# SpringBank Hill Community Association LOC2023-0127 Presentation

# Request

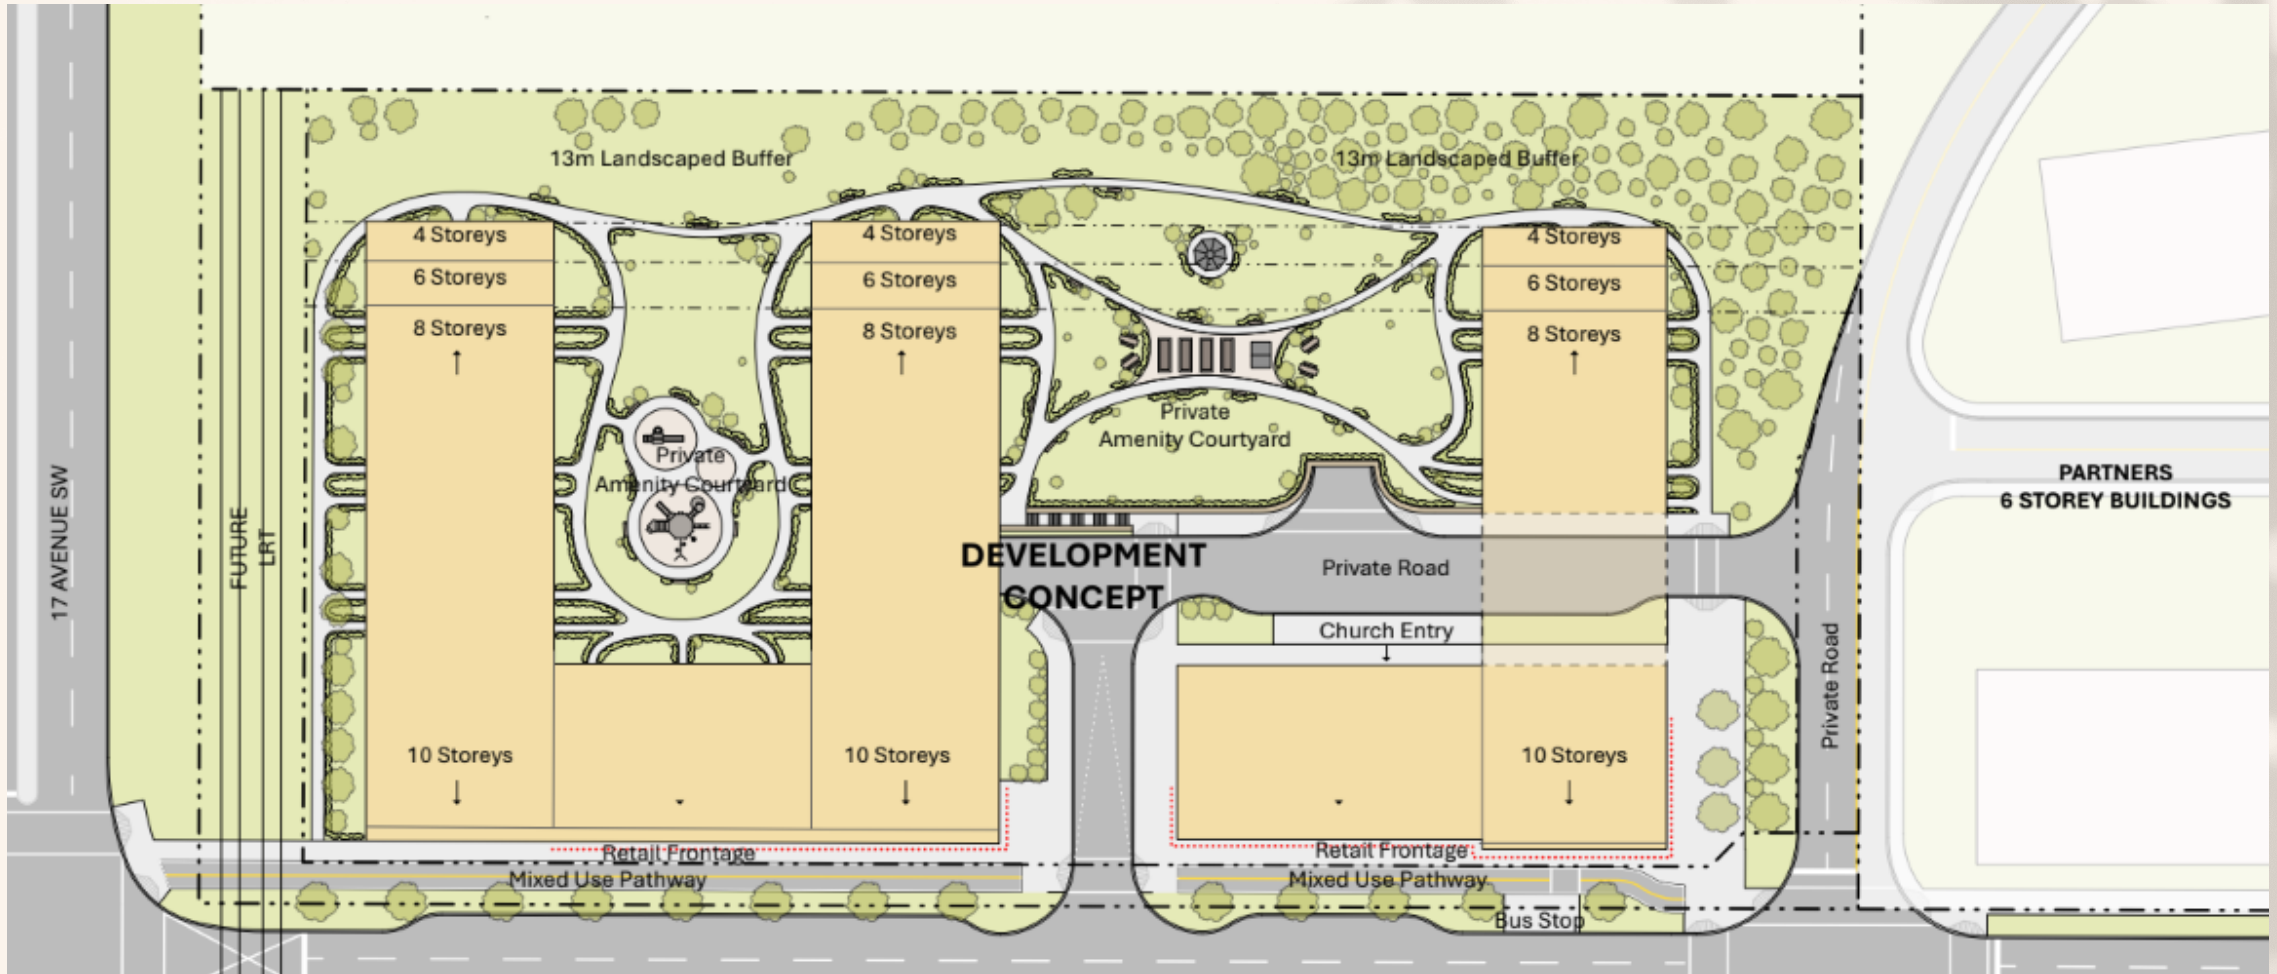
- Standard Suburban to 63,000 sq meter - 10 Story Mixed Used development
- No defined .19ha municipal reserve – DC proposal put forward by planning

- 13m setback from the eastern property line
- 45 degree angle from 4 storeys to the east to 10 storeys on the west
  - previously stepped approach
